RALPH A. AND KIMBERLY S. HARGROVE KRESS
BUILDING SUBDIVISION

APPLICATION NUMBER 3 DATE July 24, 2008
APPLICANT Ralph A. and Kimberly S. Hargrove Kress Building Subdivision
REQUEST Subdivision

DETAIL SITE PLAN

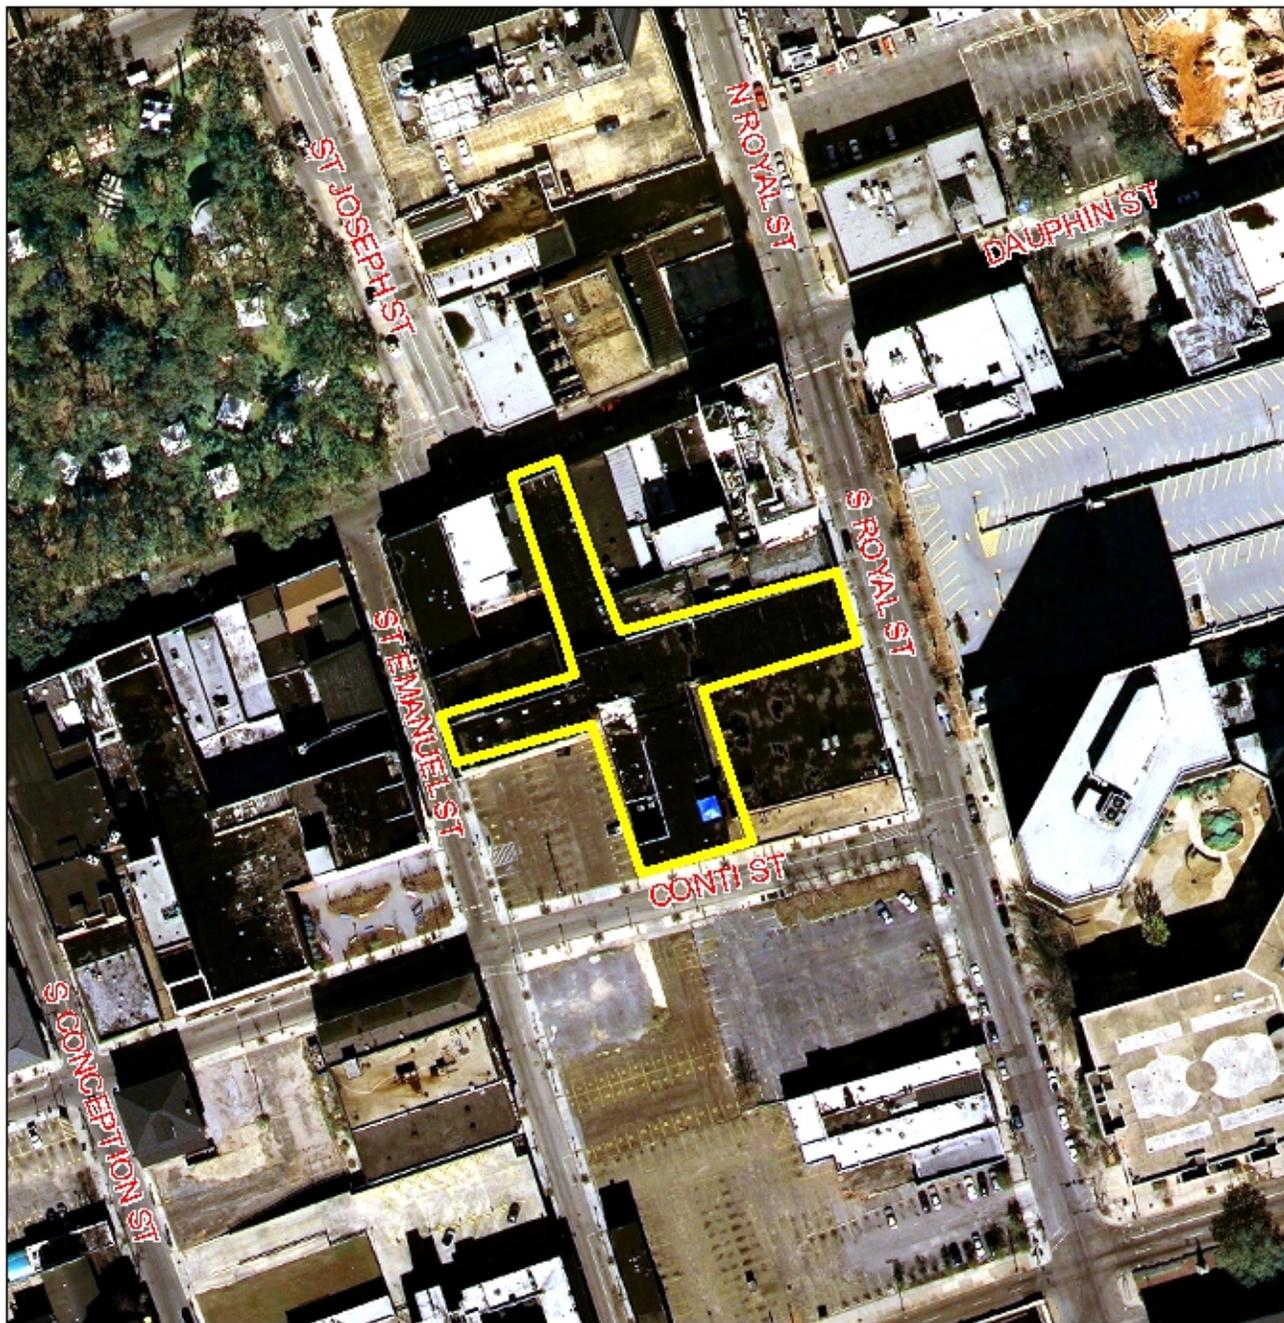
The site fronts onto Royal Street, St. Emanuel Street, Dauphin Street, and Conti Street, all minor streets. No right-of-way widths were provided for any of the streets; therefore, no determination can be made as to whether or not dedication is required. The plat should be revised to indicate the right-of-way widths of all four streets. As the proposed common street access alley opens onto Conti Street, a note should be placed on the final plat stating that the alley is limited to one curb cut, with the size, location and design to be approved by Traffic Engineering and conform to AASHTO standards.

The 25-foot minimum building setback line, required in Section V.D.9., is not shown for the subdivision, however, the site is located in downtown Mobile in a B-4, General Business District, which has no minimum building setback requirements. The setback requirements of the Subdivision Regulations should be waived in favor of those required by the Zoning Ordinance. A note should be placed on the plat stating that there are no minimum building setbacks.

Each lot is labeled with its size in square feet and this should also be done on the final plat, or a table should be provided furnishing the same information.

- 1) revision of the plat to indicate that the central courtyard common area is open-air with no floor or roof above;
- 2) revision of the plat to indicate the right-of-way widths of all four fronting streets; and
- 3) submission of a Planned Unit Development application to address the shared access to the common areas.

All street right-of-way widths are indicated to be compliant, with the exception of St. Emanuel Street, which is indicated to have a 36' right-of-way. However, since the site is located within the downtown core area with the existing building façade located on the right-of-way line, which is allowed by the Zoning Ordinance in a B-4, General Business District, dedication would be impractical.

With a waiver of Section V.D.9. of the Subdivision Regulations (Minimum Front Yard Setback), the plat is recommended for Tentative Approval, subject to the following conditions:

- 1) placement of a note on the final plat stating that the maintenance of the common areas, including the Conti Street access alley, is the responsibility of the property owners and not the City of Mobile;

- 2) placement of a note on the final plat stating that the Conti Street access alley is limited to one curb cut, with the size, location and design to be approved by Traffic Engineering and conform to AASHTO standards.

- 3) placement of a note on the final plat stating that there are no minimum building setbacks;
- 4) labeling of each lot with its size in square feet, or the provision of a table on the final plat furnishing the same information; and

- 5) subject to the Engineering Comments: *(Show Minimum FFE on plans and plat for all lots located within the X-Shaded and AE Flood Zones. No fill allowed within a special flood hazard area without providing compensation or completing a flood study showing that there is no rise for the proposed fill within the special flood hazard area. Must comply with all storm water and flood control ordinances. Cannot concentrate storm water runoff to an adjacent property without a release agreement or a private drainage easement. Must provide detention for any impervious area added since 1984 in excess of 4,000 square feet. Any work performed in the right of way will require a right of way permit. Need to verify that there is sufficient capacity for the receiving drainage system to accept drainage from this property).*
